REGIONAL REVIEW FINDING

Name of Proposal: Columbia Park

SUBJECT: **Transportation Division Review of DRI # 2453**

DRI SITE PLAN

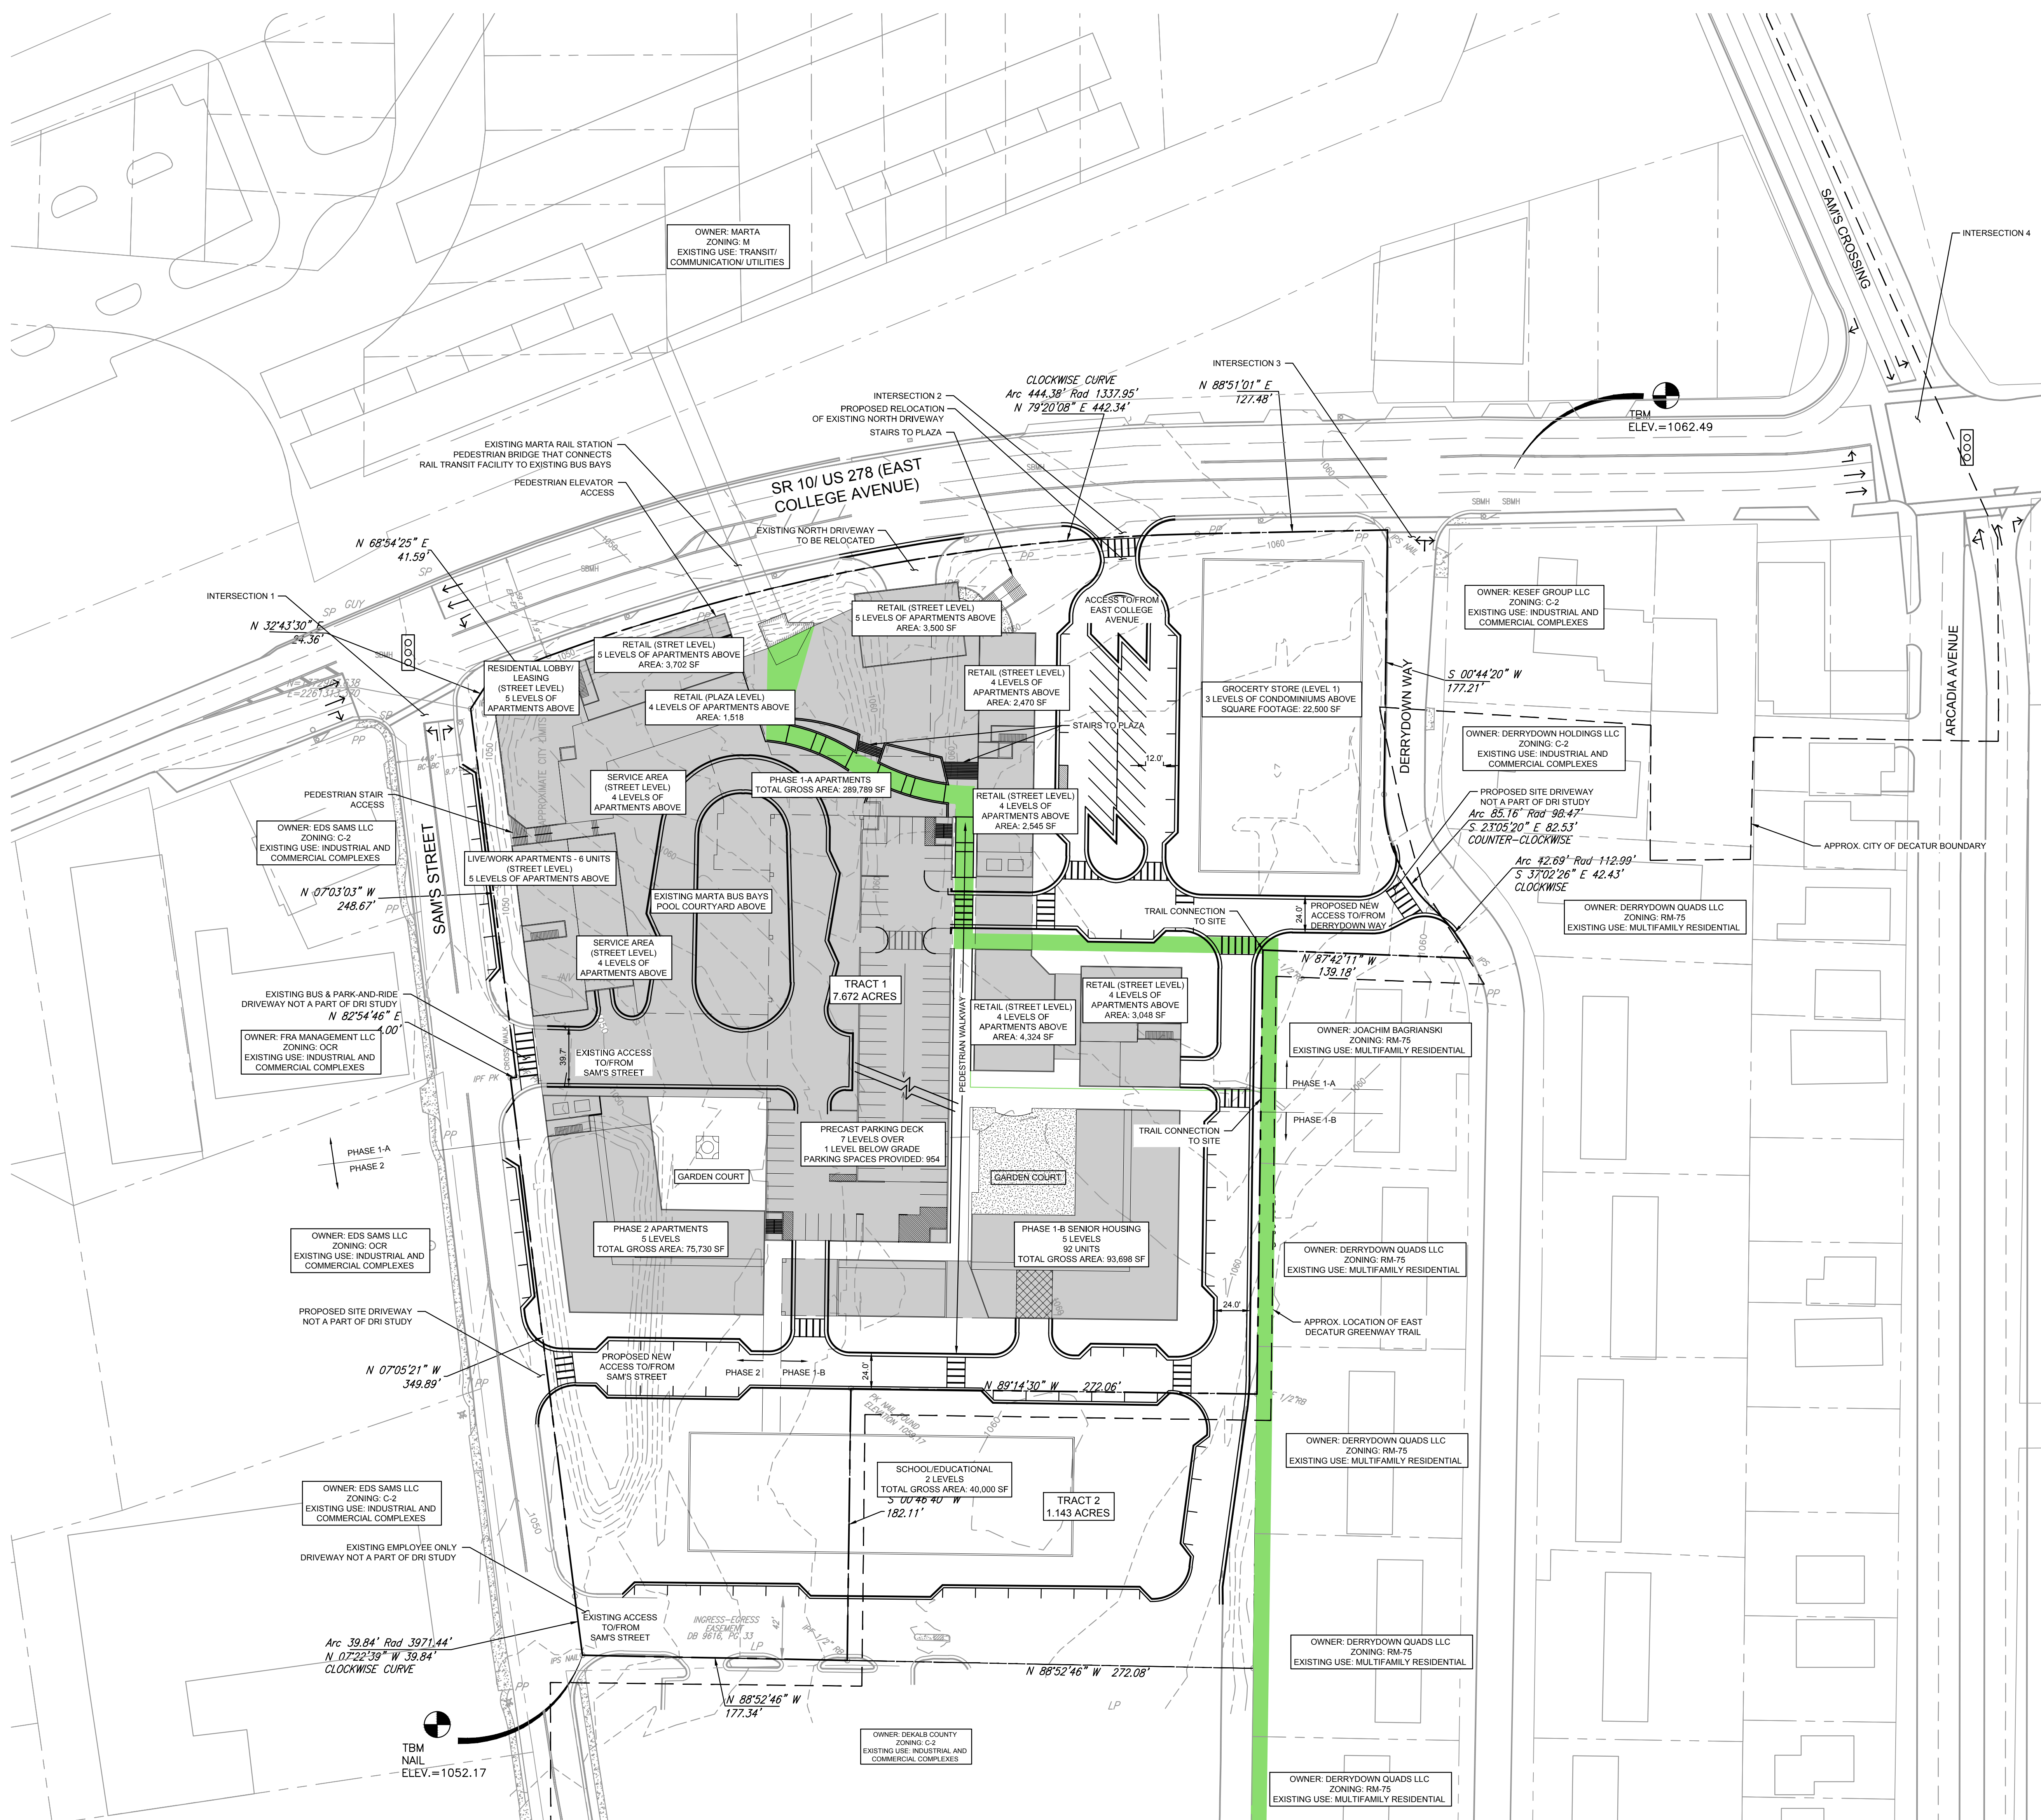
Adequate loading zones should be provided for all uses, particularly all retail and restaurant uses. The proposed grocery store will generate a significant amount of truck traffic. It is unclear from the site plan where trucks will park while unloading at the grocery store. Adequate truck parking and loading zones should be provided on-site for the grocery store and not on adjacent roadways. Additionally, the site design and access points should provide adequate space and turning radii for trucks to enter and exit the site without creating turning conflicts with vehicles on the adjacent roadways or impacting the curbs or streetscape features at the access points.
